A position of Drg. No. 10P 702-107 Alt-U

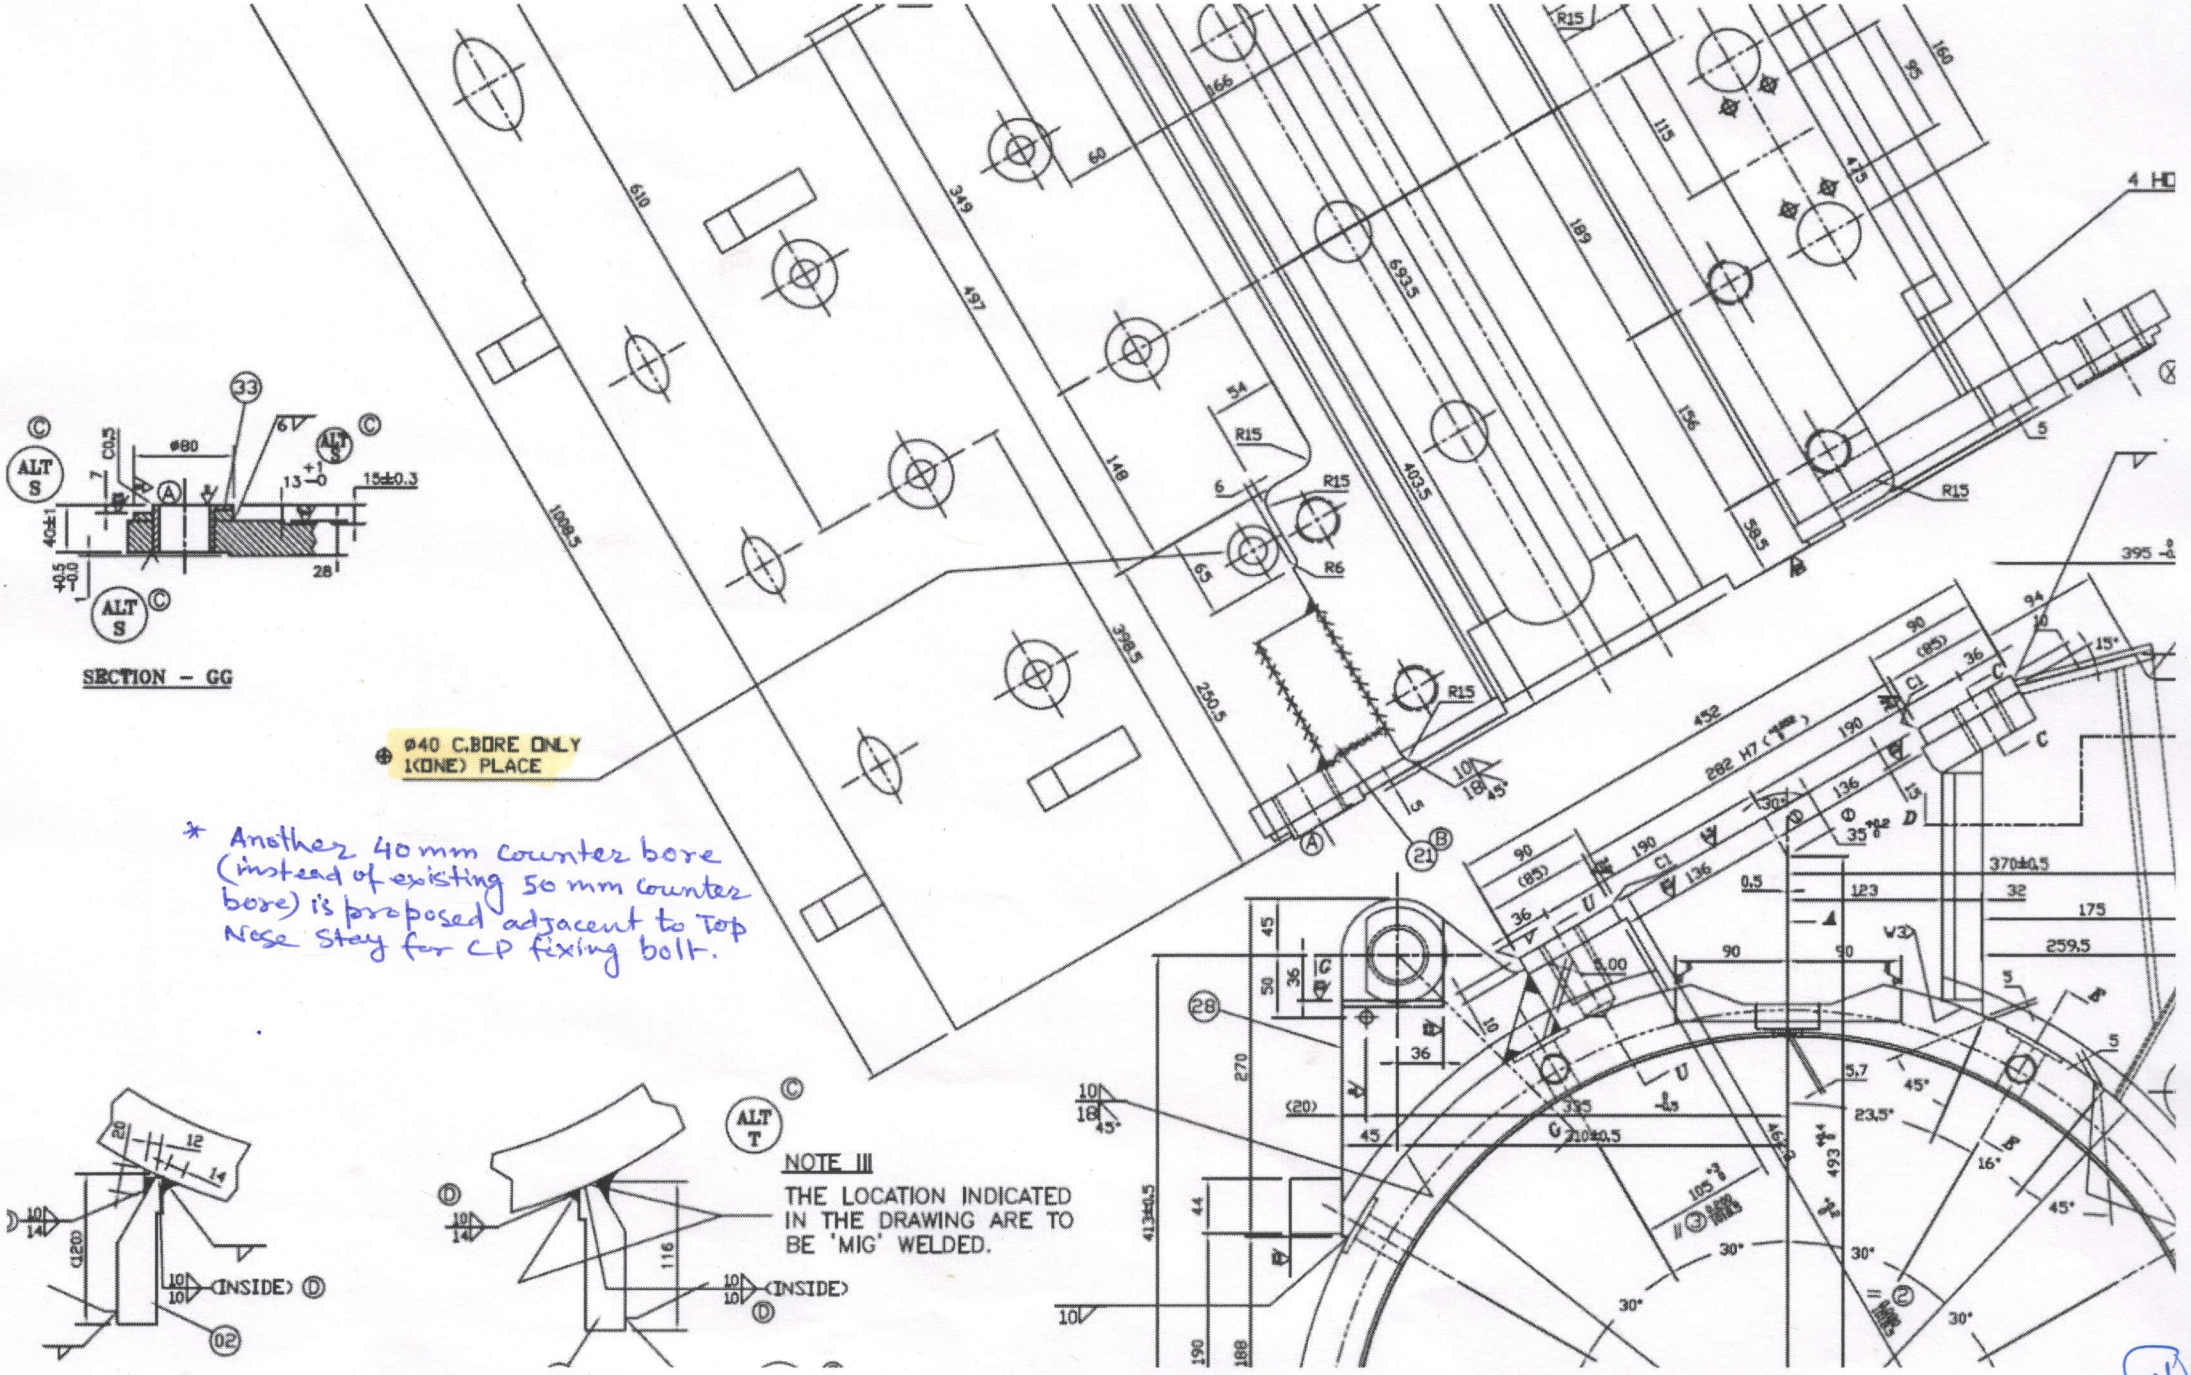
* Another 40 mm counter bore (instead of existing 50 mm counter bore) is proposed adjacent to Top Nose Stay for CP fixing bolt.
